Confirm that the vehicle is involved in Safety Recall 0182 and has one of the affected shocks installed. If the status includes an open for Safety Recall 0181, perform only this recall (0182). Safety Recall 0181 will be closed automatically by Harley-Davidson once the 0182 claim is issued credit.

Figure 2. Rework Mounting Hole

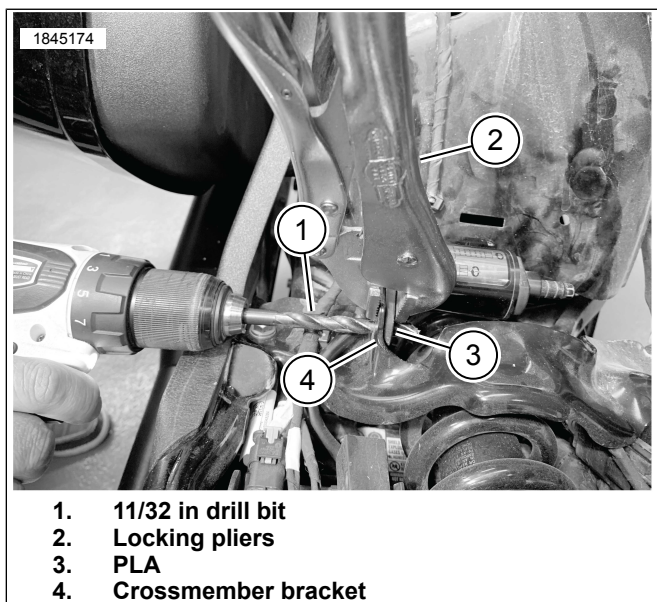
1. Remove seat. See service manual.
2. See Figure 2. Install locking pliers (2) to Pre-Load Adjuster (PLA) (3) and crossmember bracket (4).
3. Remove Original Equipment (OE) 1/4-20 inch screw.

4. Using 11/32 inch drill bit (1), drill through crossmember bracket (4) and PLA (3).
 - a. Using the existing hole on crossmember bracket (4) as a guide.
5. Remove locking pliers (2) and separate the PLA (3) from crossmember bracket (4).
 - a. Remove any burrs from drilling the components.
 - b. Clean metal chips from under the seat area.
 - c. Using Frame Paint Touch-Up Pen (Part No. 93936) or local approved equivalent for international dealers, touch up the brackets from drilling and to prevent any corrosion from forming.
 - d. Allow paint to dry.

Figure 3. Recall Kit Installed

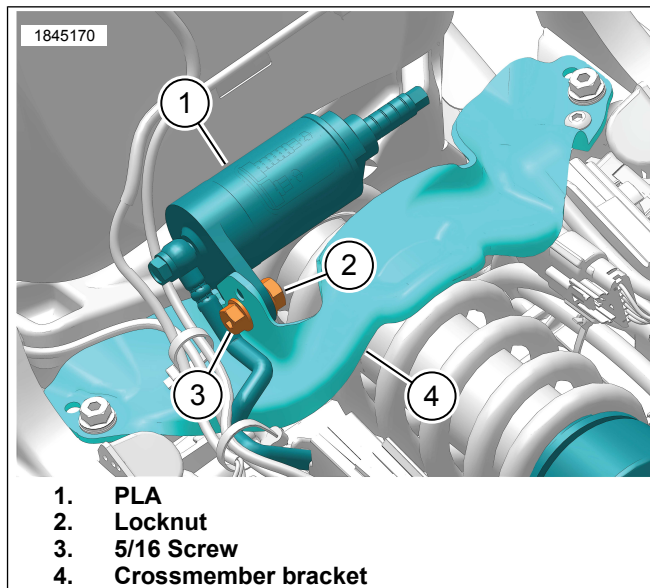
6. See Figure 3. Install PLA (1) to crossmember (4).
7. Install 5/16-inch screw (3) and locknut (2). Tighten.
Torque: 32.8–36.3 N·m (24–27 ft-lbs)
8. Install seat. See service manual.
 - a. After installing seat, pull upward on seat to be sure it is locked in position.
